1815 Montreal Road

Planning Rationale Addendum
Zoning By-law Amendment + Site Plan Control Application
October 6, 2025

Prepared for 14193679 Canada Inc.

Figure 1: Truck turning template extracted from the TIA, showing an HSU truck reversing into the layby to exit the site, prepared by CGH Transportation

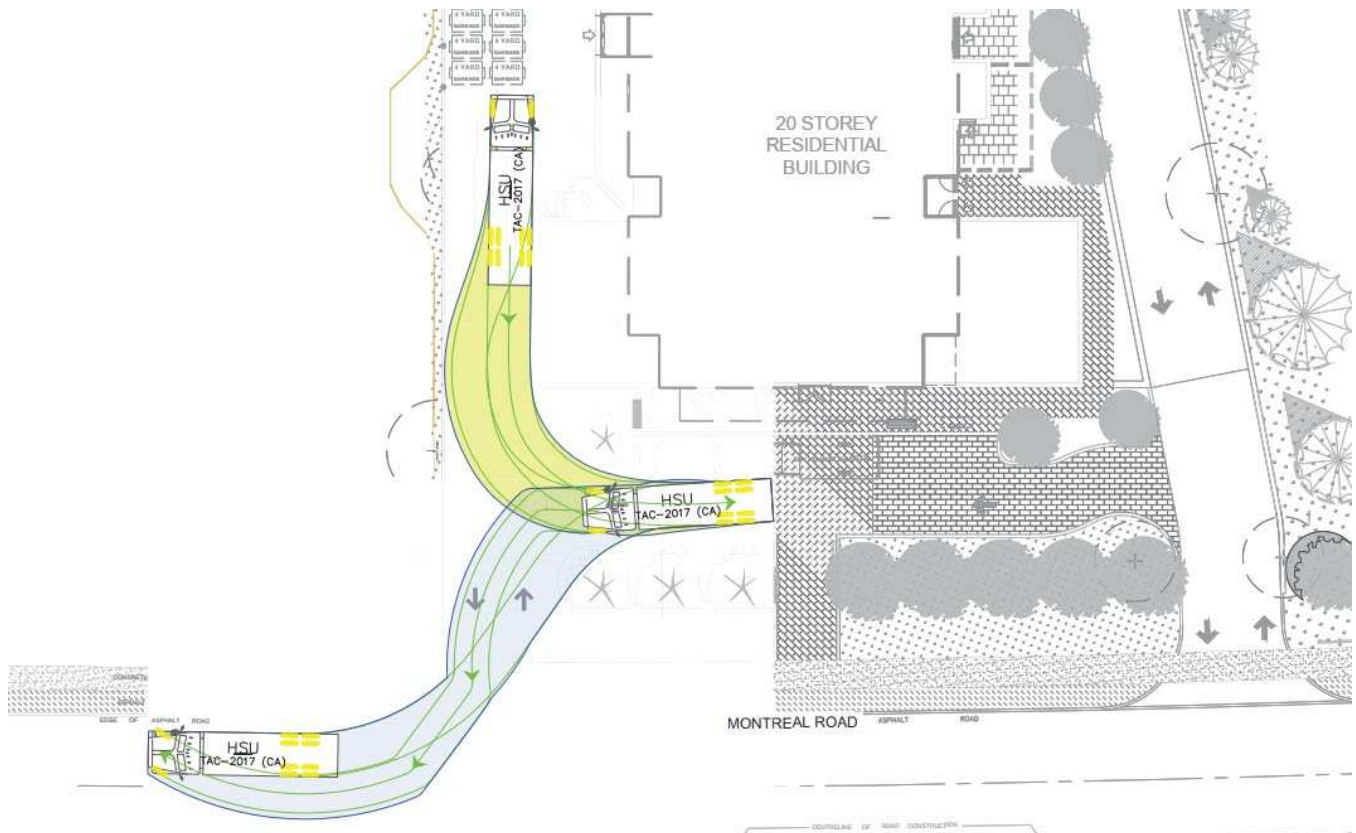
- / Widening of the servicing lane, from 4 to 6 metres, on the west side of the property to facilitate use by trucks and subsequent narrowing of the podium on the west side of the building;
 - Access to the bicycle room and move-in/ move-out room at-grade is maintained;
 - Heavy Single Unit (HSU) trucks will be able to reverse into the layby to turn around and exit the site rather than reversing onto Montreal Road, as shown in Figure 1, below:

Figure 4: Revised Site Plan showing the changes made to date on the ground floor (Site Plan prepared by RLA Architecture)

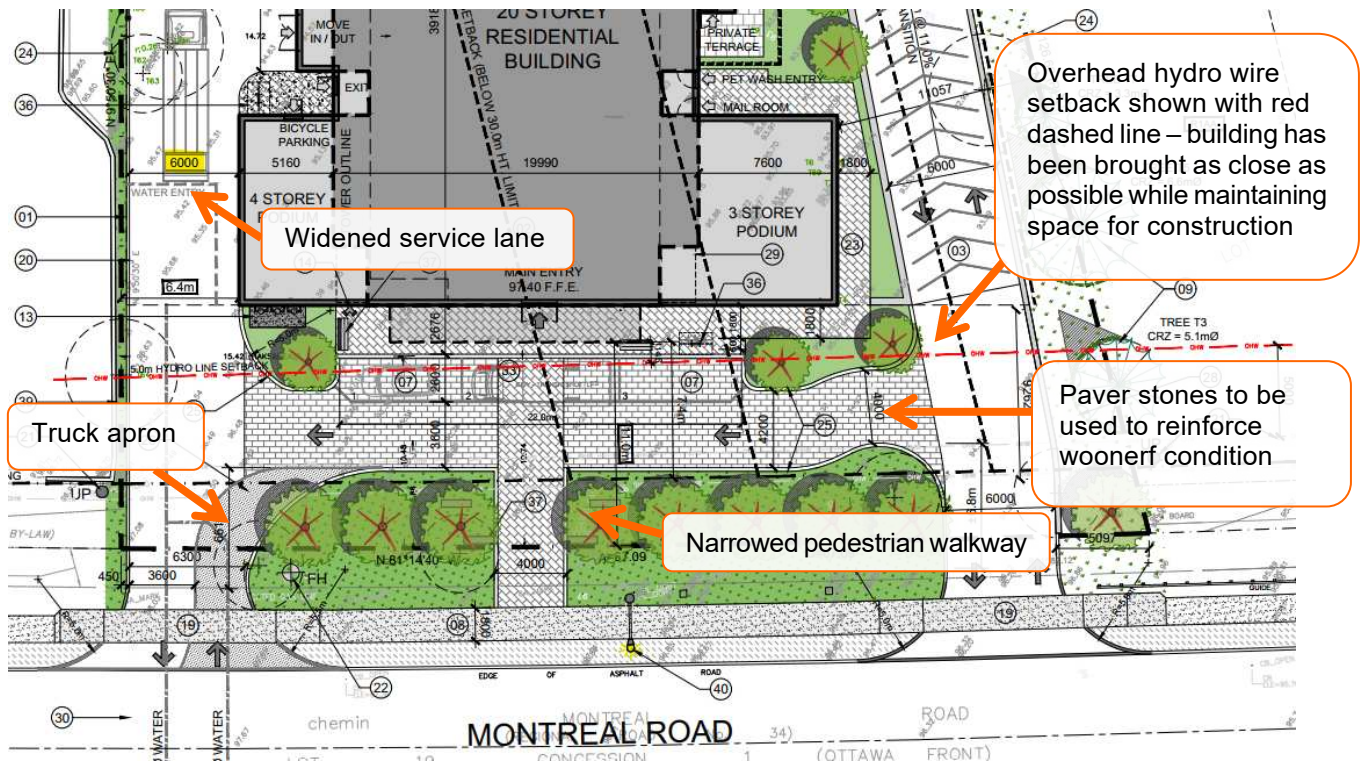
- / Tower setbacks are increased to the rear:
 - One (1) unit on the 17th and 18th storeys has been removed and converted to a patio to increase the tower setback to the rear yard, thereby reducing the height and impact of the tower;
 - One (1) unit on the 19th storey has been removed to increase the tower setback to the rear yard, thereby reducing the height and impact of the tower;
- / On the rooftop, the party room has been removed, and the rooftop patio has been adjusted so that it faces the north, east, and south rather than just the north;
 - The building has therefore been reduced in height from a 21- to a 20-storey height, as the removal of the rooftop party room eliminates it as a “storey” per the Zoning By-law definition. As described in the

- / The pedestrian walkway leading to the building from Montreal Road has been narrowed to ensure a motor vehicle cannot be illegally parked there and block the path, per the recommendation from Transportation staff.

Figure 6: Comparison of the angular plane measured from the property line of 201 Rothwell Circle to the east, comparing the previous submission (left) and the current resubmission (right)

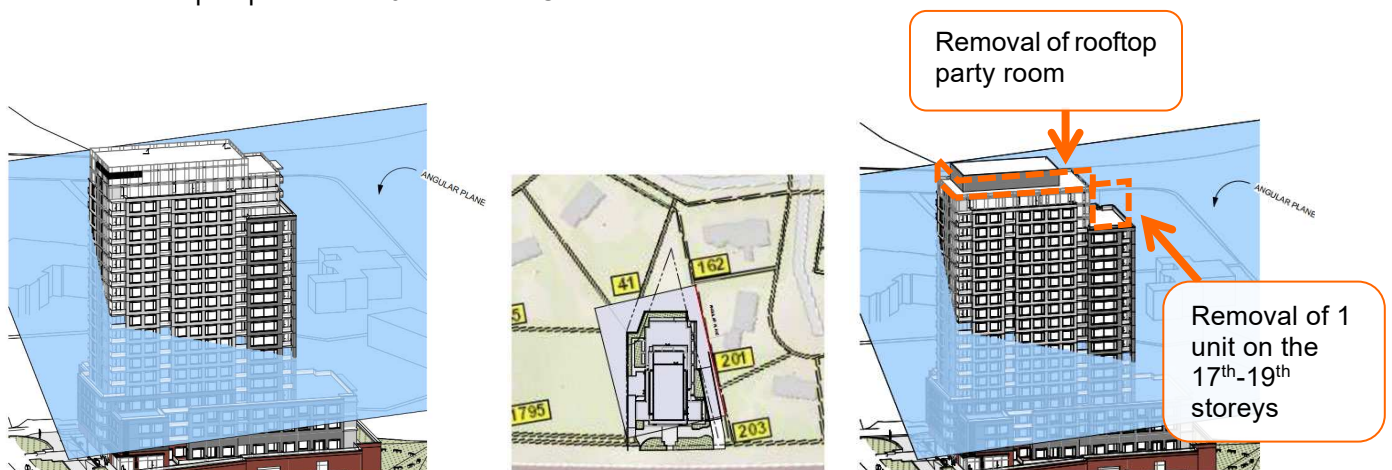
As shown in the angular plane diagrams below, the amount of the building projecting into the angular plane has been reduced from the perspective of 201 Rothwell Circle:

Figure 8: Comparison of the angular plane measured from the property line of 41 Cedar Road to the northwest, comparing the previous submission (left) and the current resubmission (right)

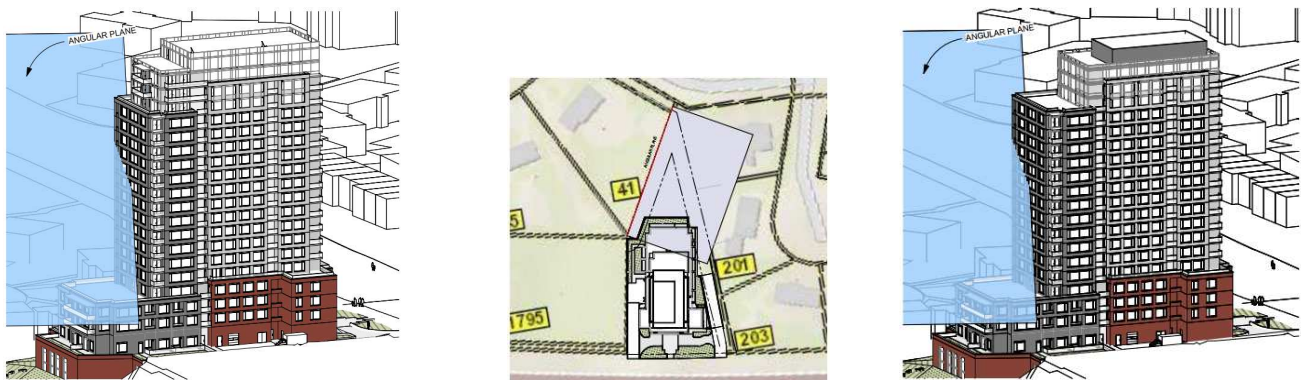
As with the previous submission, regardless of whether you measure the angular plane from the property line or the minimum required rear yard setback for 41 Cedar Road, the building only demonstrates a modest projection into the angular plane from 201 Rothwell Circle. This degree projection into the angular plane has been maintained with the present resubmission:

Figure 11: Screenshot of the Landscape Plan, prepared by GJA Inc.

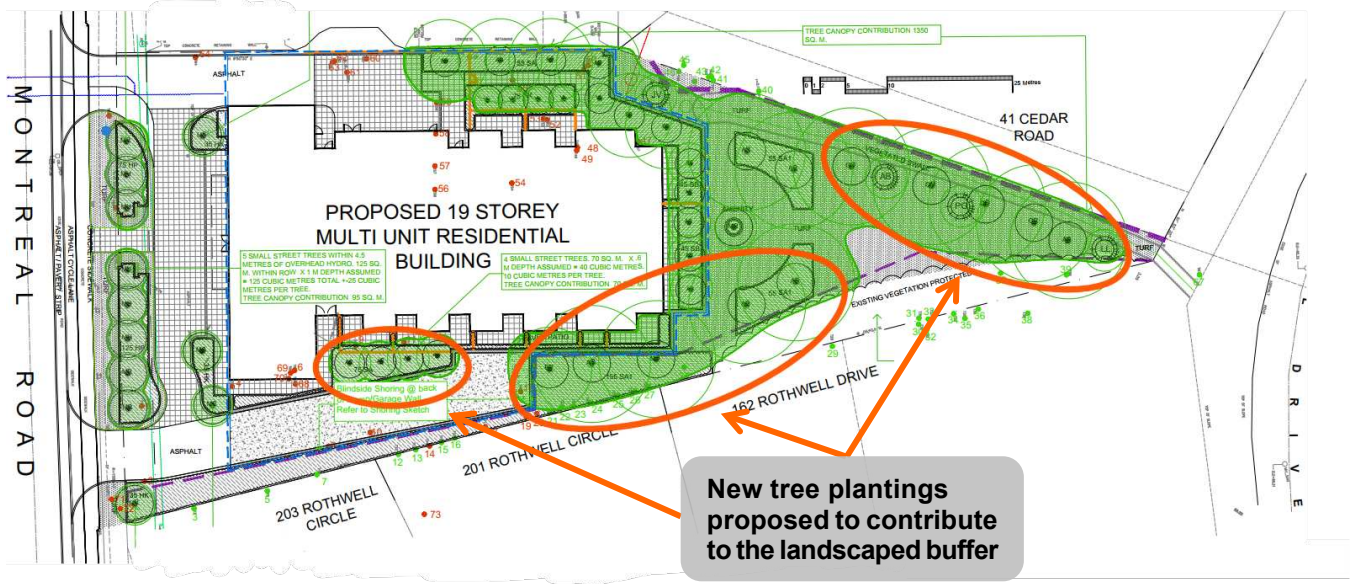
As shown in the Tree Conservation Report (TCR), many of these trees will be protected to maintain this buffer and expanded with additional native plantings. For instance, as shown on the Landscape Plan prepared by GJA Inc., multiple new tree plantings will contribute to the landscaped buffer, outlined in orange in Figure 10, below:

Trees proposed include: paper birch, red maple, cucumber magnolia, sugar maple, eastern larch / tamarack, red oak, common hackberry, bur oak, and tree serviceberry.
